2018/01/08

MVBA-2100/MVBAT series " manufacture process" change and use " Laser engraving label " Notification

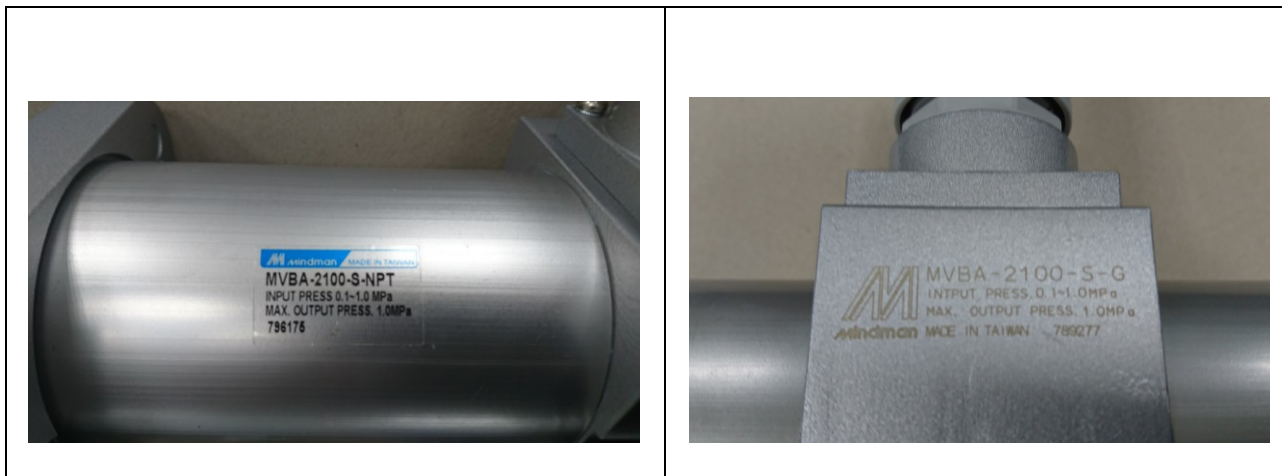
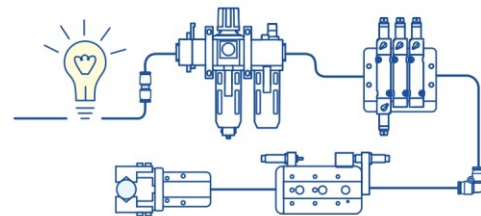
- A. In order to facilitate the manufacture, change the product surface treatment and manufacture process.
- B. Reduce the label easy to fall off and identify product the problem. The use of laser engraving labels.

Before	After
1. Aluminum extrusion type manufacture/Anodized aluminum: Body, Mounting, Bonnet Holder, Cover, Body side cover. 2. Paste label. Position: Above the cylinder tube.	1. Die casting manufacture/ Baked Painting. Body, Mounting, Bonnet Holder, Cover, Body side cover. 2. Laser engravings label. Position: Above the back of the body
